Wholesale Electricity Market Rule Change Proposal Submission

RC_2019_03

Method used for the assignment of Certified Reserve Capacity to Intermittent Generators

Name:	Neetika Kapani
Phone:	(08) 9469 9936
Email:	neetika.kapani@aemo.com.au
Organisation:	Australian Energy Market Operator
Address:	GPO Box 2008, Melbourne VIC 3001
Date submitted:	19 May 2021

Figure 1. Average and Standard Deviation of Facility Performance Level (FPL) ^A

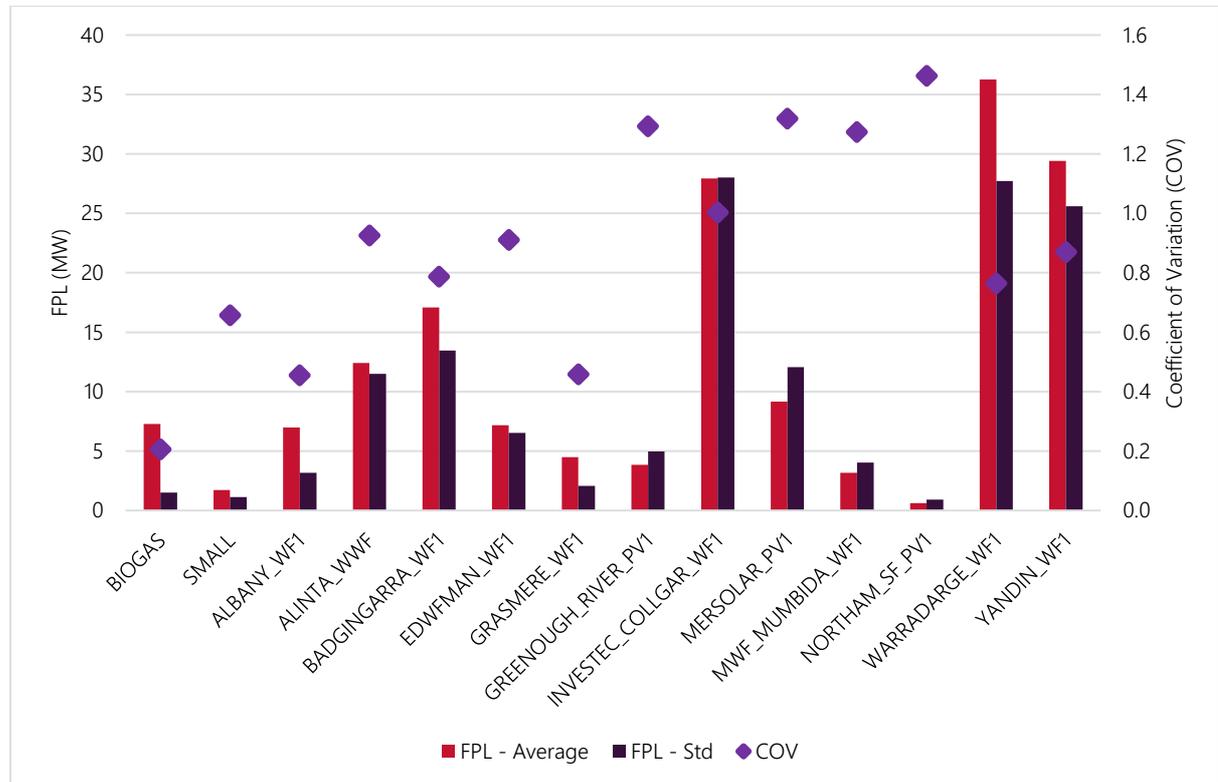
AEMO encourages the RCP to explore solutions to mitigate this potential volatility in the ELCC of individual Candidates. This would essentially yield a more stable locational price signal for the investment in IGs in the SWIS. AEMO proposes two potential approaches for the RCP to investigate to assist with its final decision:

- 1) Considering the ELCC of individual Candidates allocated by the Delta Method as a baseline and adjusting this baseline based on the concepts of the average and standard deviation of the Candidate's performance level during a selected number of Trading Intervals with the highest Scaled Demand and Net Demand⁷. Candidates that have shown a relatively stable historical output that is above this baseline during these relevant Trading Intervals would be rewarded (i.e. high average and low standard deviation) and vice versa. Both variables could be accounted for by using the coefficient of variation⁸. This approach may provide a solution that retains the consideration of the interactive effects using the Delta Method while still considering the performance of IGs over a larger number of Trading Intervals with high system stress.

Figure 1 shows the average and standard deviation of Candidate Facilities' performance level calculated based on the 100 Trading Intervals⁹ and the coefficient of variation. As shown in Figure 1, wind farms in the south (Albany and Grasmere) show relatively small coefficients of variation compared to those wind farms in the north and east. This suggests that wind farms in the south can maintain relatively less variable output compared to other wind farms during high system stress periods.

Figure 2. Delta Method allocated ELCC, average performance level, maximum capacity of Candidate Facilities

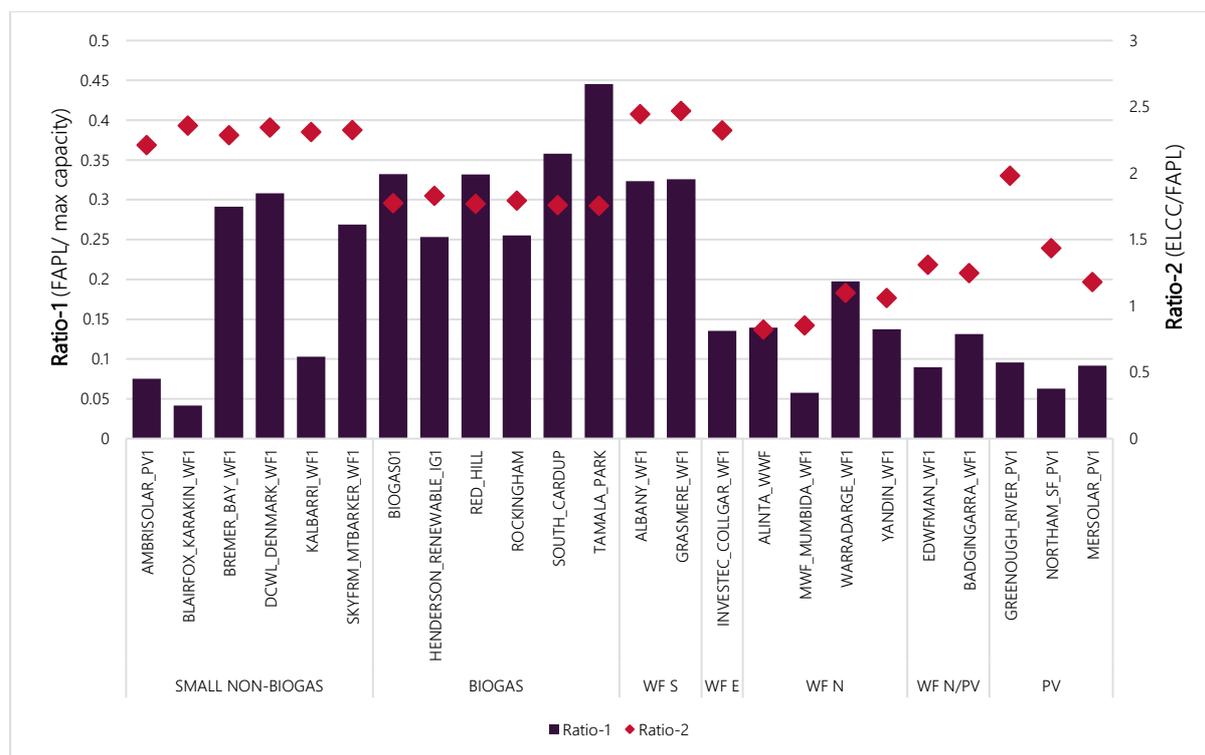
Figure 2 presents the ratio of the Facility average performance level (**FAPL**)¹⁶ over the maximum capacity (**Ratio-1**) and the ratio of the Delta Method allocated ELCC over the FAPL (**Ratio-2**) for each individual Candidate Facility. The Candidate Facilities are grouped into categories, namely, the non-biogas and biogas groups (<10 MW¹⁷) as well as other groups based on technology and geographical locations (for wind farms). Figure 2 shows that:

- Ratio-1 of the small Candidate Facilities in the non-biogas group vary greatly, while they are similar within the biogas group.
- For wind farms located in the north, the Ratio-2 of small wind farms that are included in the non-biogas group (BLAIRFOX_KARAKIN_WF1 and KALBARRI_WF1) are noticeably higher than the Ratio-2 of large wind farms.
- For wind farms located in the south, the Ratio-2 of small wind farms that are included in the non-biogas group are slightly lower than the Ratio-2 of the two wind farms that are not included in the non-biogas group (ALBANY_WF1 and GRASMERE_WF1).

These observations suggest that the grouping may disadvantage small wind farms located in the south while benefit small wind farms located in the north. AEMO encourages the RCP to carry out further analysis to confirm whether:

- Variability among individual small Candidate Facilities in the non-biogas group would have any material impact on the allocation of the group ELCC to the individual small Facilities.
- It is feasible to group small Candidate Facilities using a smaller threshold while considering their geographical locations.
